1.0 APPLICATION SUMMARY

The subject site is zoned PD (Planned Development) PD 21-0748 and approved for a 620-bed (124 units) student housing development. The current approval includes approval of a density bonus (Policy 23.5 – Residential Infill Density Bonus to 50 units per acre) from the RMU-35 Future Land Use (FLU) category. Under this application, the applicant is requesting various changes to previously approved development standards.

APPLICATION NUMBER: PRS 24-0024

2.4 Proposed Site Plan (partial provided below for size and orientation purposes. See Section 8.2 for full site plan)

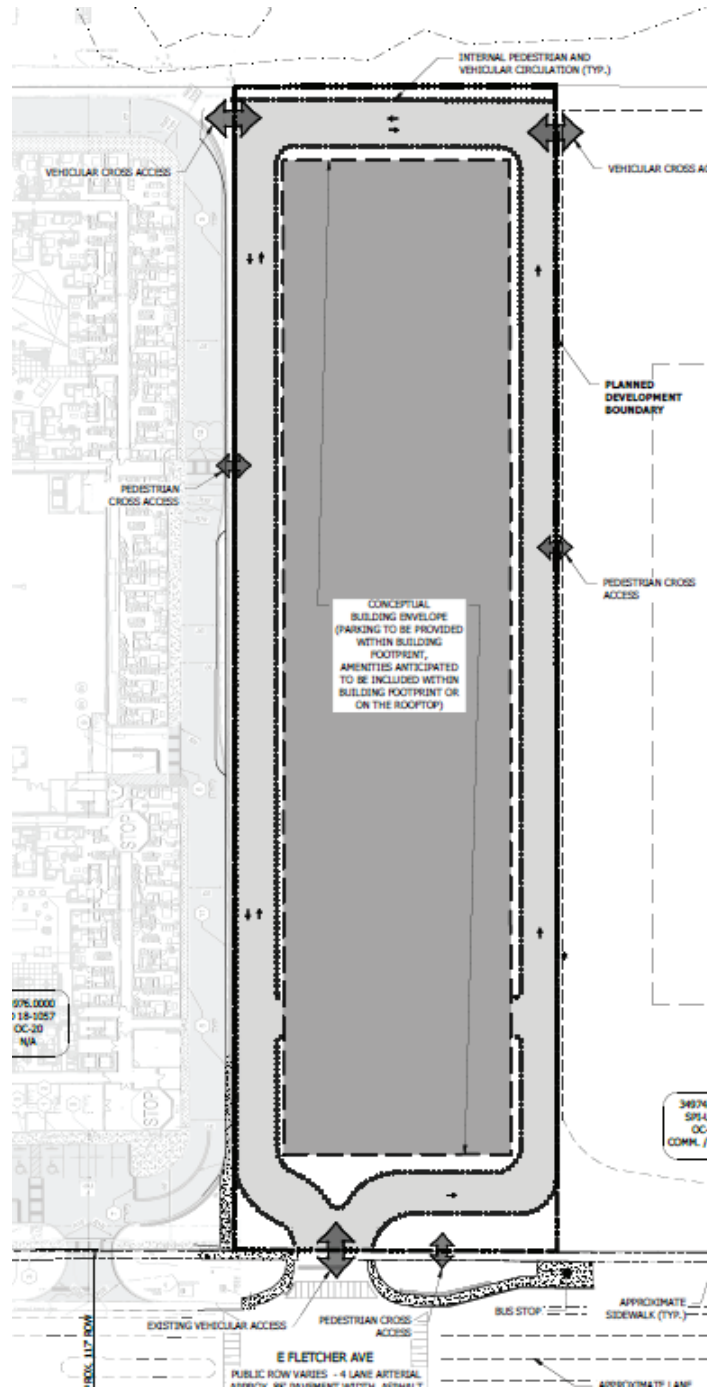
Since the approval, the proposed configuration of the building has changed to provide better efficiency and construction costs, which results in various setback changes.

The current front yard setback varies between 52 feet for the first floor and 25 feet for the upper floors. The proposed front yard setback of 40 feet (first floor) is decreased by 12 feet. The proposed front yard setback of 40 (upper floors) increases the setback by 15 feet. This will provide an increased front setback for the bulk of the building. The front of the building fronts Fletcher Avenue at the signalized intersection of Fletcher Avenue and Magnolia Drive.

The current west side yard setback varies between 32 feet for the first floor and 25 feet for the upper floors. The proposed setback of 23 feet for the first floor will reduce the setback by 9 feet. The proposed setback of 20 feet for the upper floors will decrease the setback by 5 feet. The western portion of the project abuts a 780-bed student housing project approved for a maximum of 80 feet in height and an eastern setback of 30 feet.

The current east side yard setback varies between 30 feet for the first floor and 25 feet for the upper floors. The proposed setback of 23 feet for the first floor will decrease the setback by 7 feet. The proposed setback of 20 feet for the upper floors will also decrease the setbacks by 5 feet. Property the immediate east of the site is developed with a 5 story medical office building, located approximately 77 feet from the common property line. The two buildings will be separated by a parking lot (medical building) and a one-way drive aisle (subject site).

The current rear yard setback varies between 45 for the first floor and 25 feet for the upper floors. The proposed setback of 33 feet (for both floors) will decrease the setback by 12 - 8 feet.

The maximum building coverage is proposed to increase by 15% from 50% to 65%. This is due to the re-configuration of the project. No increase in the number of beds is proposed.

Student housing portions of the building are limited a maximum of 9 stories, while parking garage portions are limited to 8 stories. The applicant proposes a maximum of 9 stories overall. No increase in the approved maximum height if 100 feet is proposed.

Lastly, traffic circulation around the building is proposed to change from one-way and two-way traffic along the west to two-way traffic only. There is no change in vehicular or pedestrian cross access points.

PD Variations

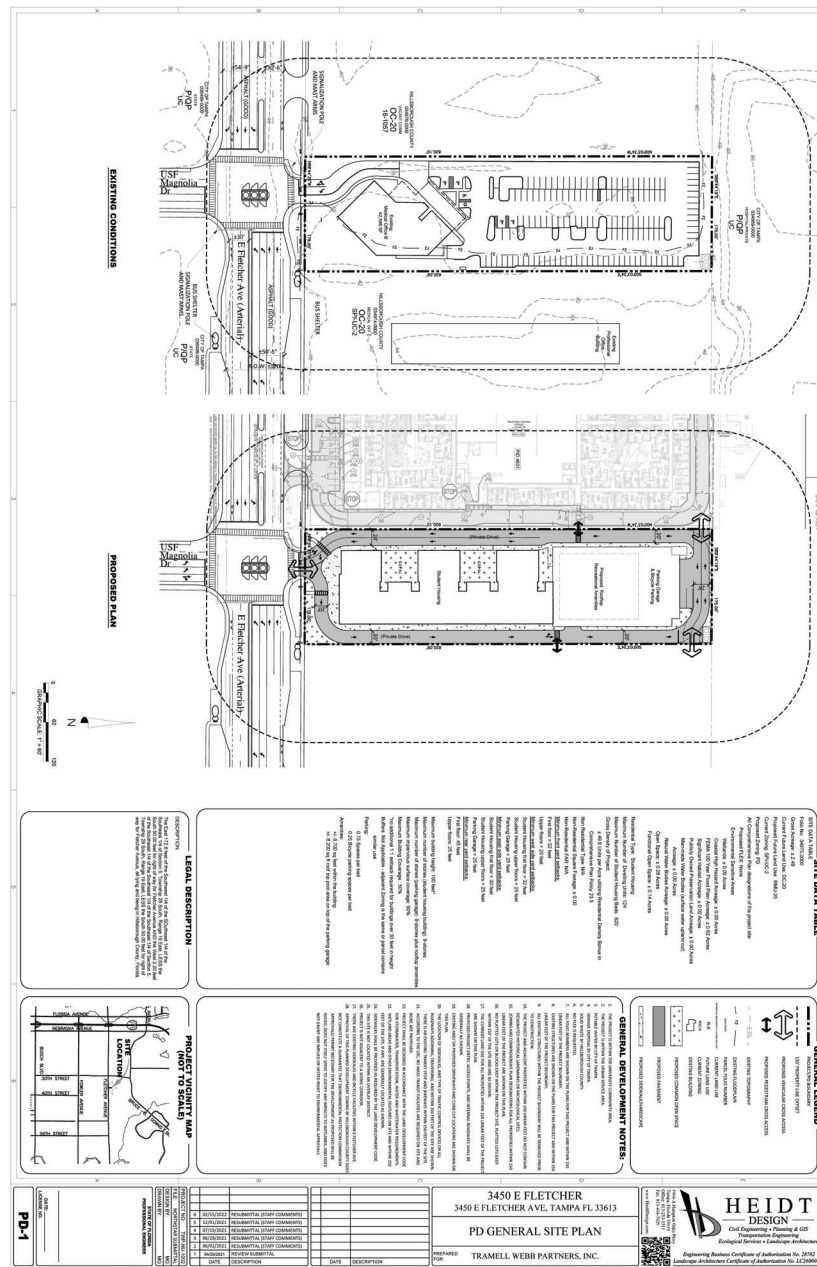
The use requires a 10 foot wide buffer with Type A screening along the northern PD boundary and a 20 foot wide buffer with Type B screening along the eastern PD boundary. The applicant requests no buffering along the northern or eastern PD boundaries. The northern PD boundary will provide Type A screening; however, the eastern PD boundary will provide Type A, rather than Type B, screening. The Type A screening will consist of a 6-foot high solid fence (excluding cross access areas). It should be noted that the project was previously approved with no required buffering or screening due to staff error.

Per the applicant's responses, the constraints of the parcel size in relation to the project does not provide adequate room for the required buffers. Property to the north is utilized for parking and stormwater for the hospital and natural vegetation is present. Property to the east is the parking lot for the adjacent medical office.

The site was previously zoned SPI-UC-2 (Special Public Interest Univerity Community), which permits non-residential uses targeted to the USF area. When properties to the north and east were developed, no buffering and screening was required; however, once the property was rezoned and became residential, buffering and screening is required on the subject site. In such instances, buffering and screening is not retroactively required on the site of the more intense use.

Staff has no objections to the proposed PD variation requests.

8.2 Proposed Site Plan (Full)

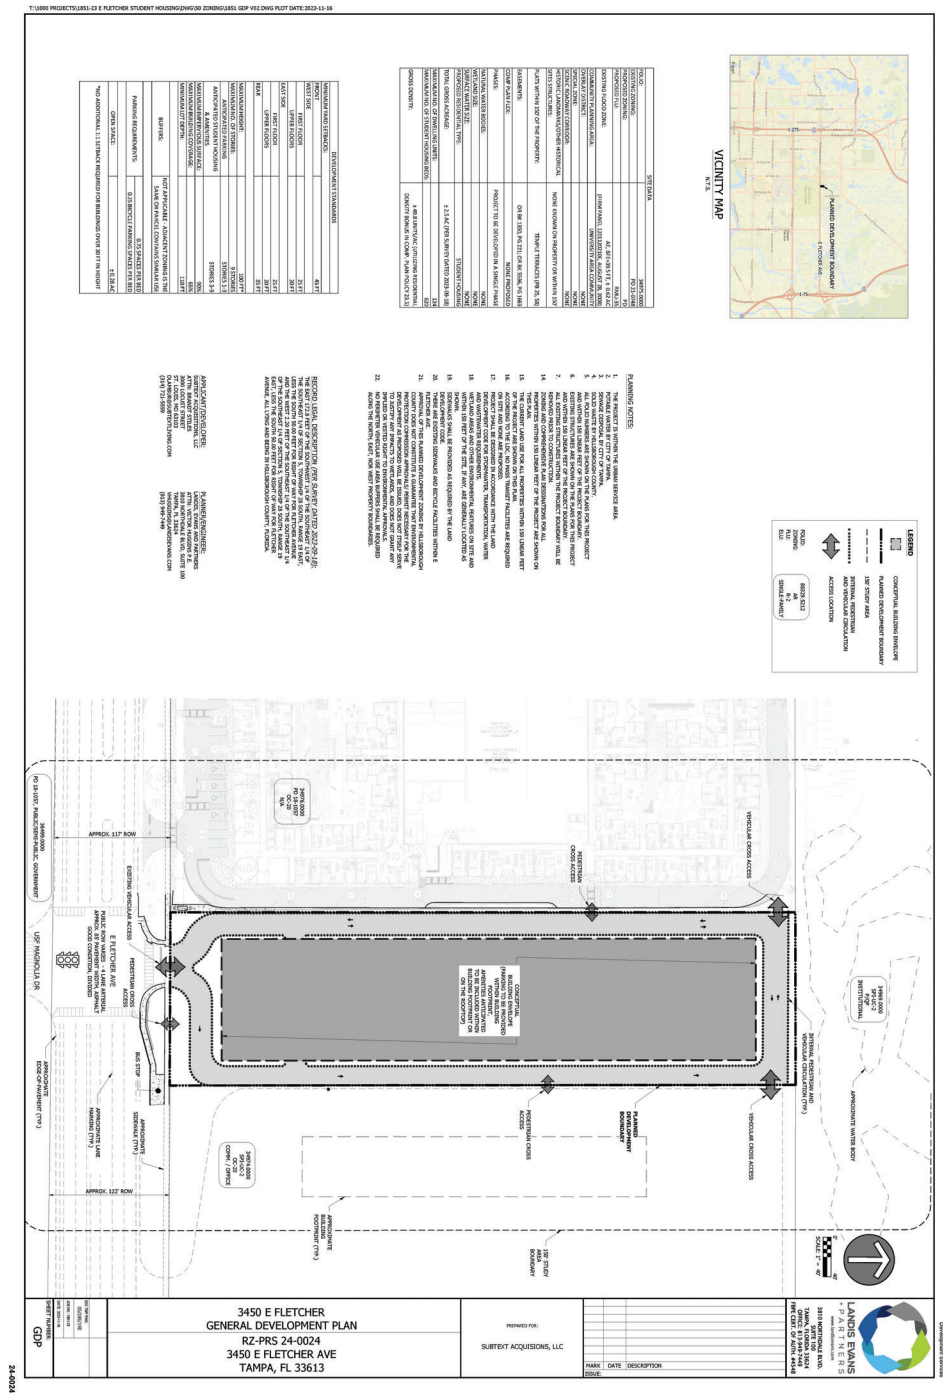
- a. Revise the PD site with respect to Fletcher Ave. right-of-way and/or Hillsborough County Corridor Preservation Plan requirements. Staff notes that the County's GIS inventory indicates +/- 150-feet of right-of-way; however, the applicant's site plan shows 117 feet of right-of-way existing. The applicant shall either determine that this value is in error and show the correct existing right-of-way or, alternatively, the applicant shall redesign the site and show/label the required right-of-way preservation in accordance with Development Review Procedures Manual and LDC requirements;

- b. Modify the label on the southern project boundary which reads "Pedestrian Cross Access" to instead read "Proposed Pedestrian Access";
 - c. Modify the label on the western project boundary from "Pedestrian Cross Access" to instead read "Proposed Pedestrian Cross Access";

- d. Modify the label on the eastern project boundary from "Pedestrian Cross Access" to instead read "Proposed Pedestrian Cross Access Stubout"; and,
 - e. Modify the label on the eastern and western project boundaries from "Vehicular Cross Access" to "Proposed Vehicular Access Stubout".

The applicant has submitted a modification to the site plan and zoning conditions which seek to provide flexibility in the building and parking garage location and design and reduce building setbacks. Staff is concerned that the setback reduction could result in a minimum standard which is unachievable, depending upon the type of curbing which will ultimately be required at the time of site/construction plan review. To address this issue, staff has included a condition which reflects internal transportation requirements, and clarifies that minimum setbacks may need to be increased as/if necessary to comply with these minimum standards.

Staff notes the above is based on the County's GIS inventory, and the applicant has shown a different value. As such, staff has included a "Prior to Certification" condition requiring the applicant to rectify the discrepancy.

Minimum front yard setback first floor:	52 <u>40</u> feet
Minimum front yard setback upper floors:	25 <u>40</u> feet
Minimum west side yard setback first floor (student housing):	32 <u>23</u> feet
Minimum west side yard setback upper floors (student housing):	25 <u>20</u> feet
Minimum west side yard setback (parking garage):	25 feet
Minimum east side yard setback first floor (student housing):	30 <u>23</u> feet
Minimum east side yard setback upper floors (student housing):	25 <u>20</u> feet
Minimum east side yard setback (parking garage):-	25 feet
Minimum rear yard setback first floor:	45 <u>33</u> feet
Minimum rear yard setback upper floors:-	25 feet
Maximum building height:	100 feet*

Maximum number of stories ~~(student housing building):~~ 9-stories
~~Maximum number of stories (parking garage):-~~ 8-stories
 Maximum impervious surface coverage: 90%
 *no additional 1:1 setback required for buildings over 30 feet in height

9. Notwithstanding anything shown on the PD site plan or herein these zoning conditions to the contrary, the developer shall construct internal transportation improvements as follows, and minimum setbacks shall be increased as necessary to comply with this condition:

- a.1 Single one-way drive aisles shall have a minimum pavement width of 15-feet within a 20-foot-wide clear area; and,
 - a.2 Dual one-way drive aisles and two-way aisles shall have a minimum pavement width of 20-feet;

- a.3 Drive aisles shall be constructed with a raised vertical curb, and there shall be a minimum of 2-feet between the back of curb and any property boundary and/or raised structures such as a fence, wall, building façade, etc.

- b. Sidewalks located adjacent to the raised vertical curbs shall be a minimum of 6-feet in width. Alternatively, sidewalks adjacent to travel pathways may be a minimum of 5-feet in width when separated from the internal drive aisles by a minimum 5-foot-wide green strip. All other internal sidewalks shall be a minimum of 5-feet in width.
